SUBJECT: NuScale Power, LLC Response to NRC Request for Additional Information No. 523 (eRAI No. 9682) on the NuScale Design Certification Application

Response to Request for Additional Information Docket No. 52-048

eRAI No.: 9682

NRC Question No.: 12.03-66

The flow path used to monitor for hydrogen includes portions of the CES, PSS and CFDS. These systems are depicted in FSAR Figures 9.3.6-1, 9.3.2-1, and 9.3.6-2, respectively. The flow path is shown below using red lines:

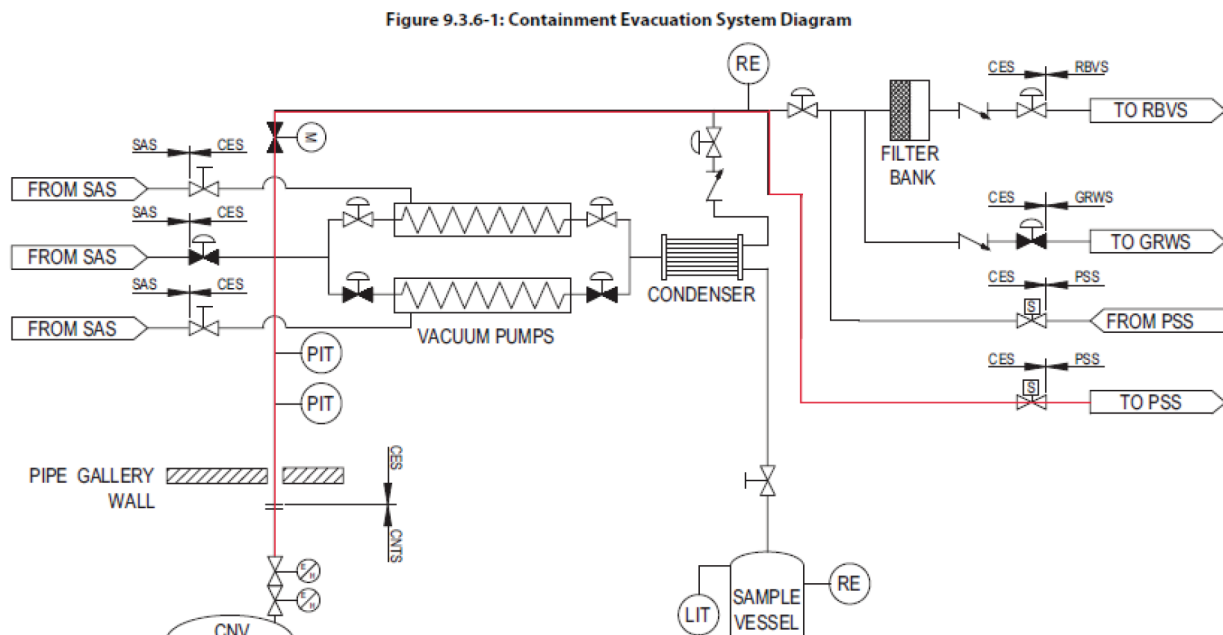
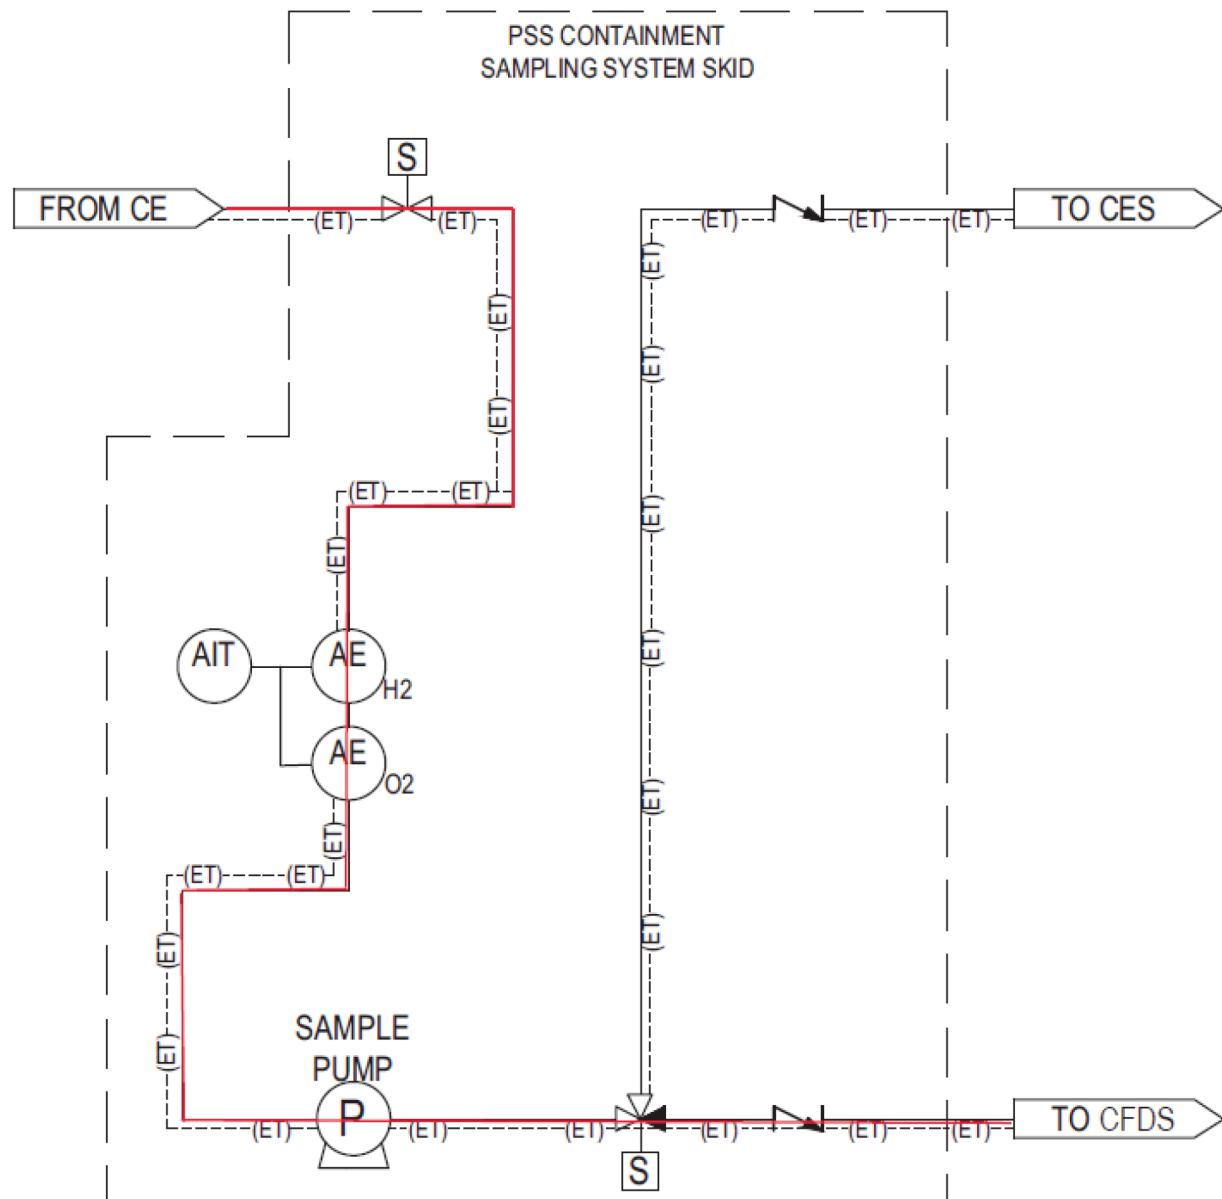
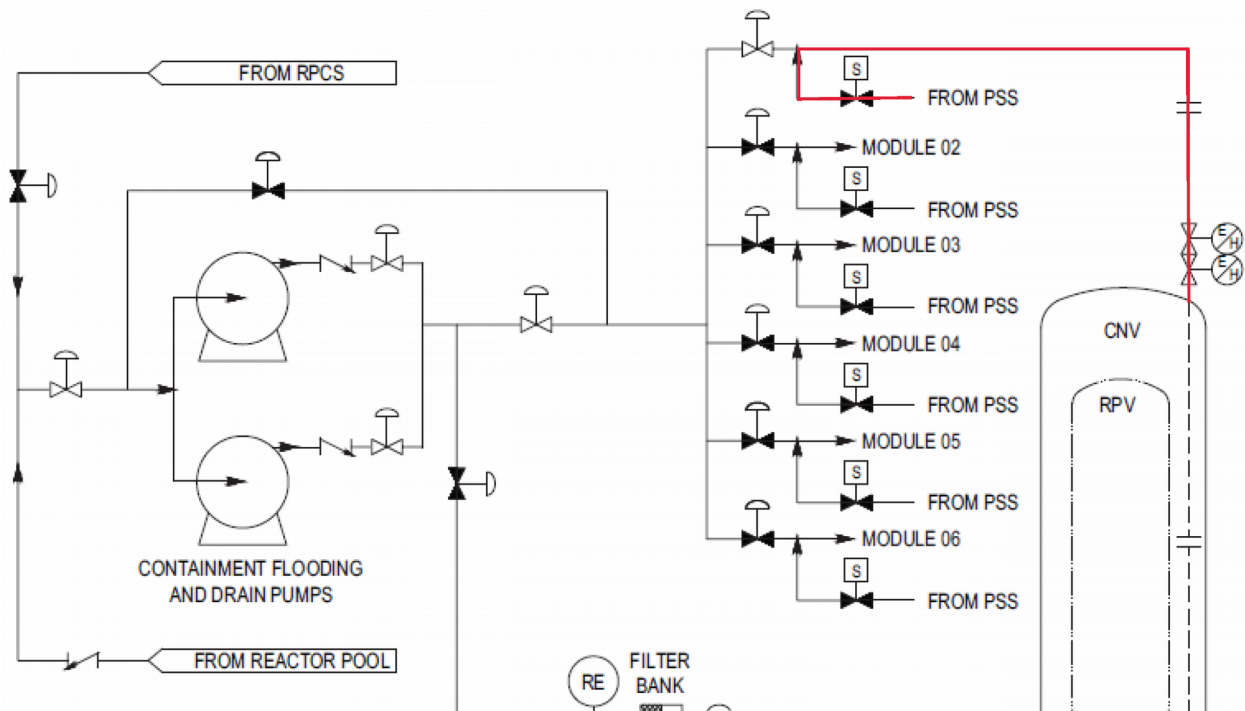
2. Provide, drawings which demonstrate the flow path, including equipment, which

would establish the continuous monitoring of hydrogen and oxygen in containment following a beyond design basis accident.
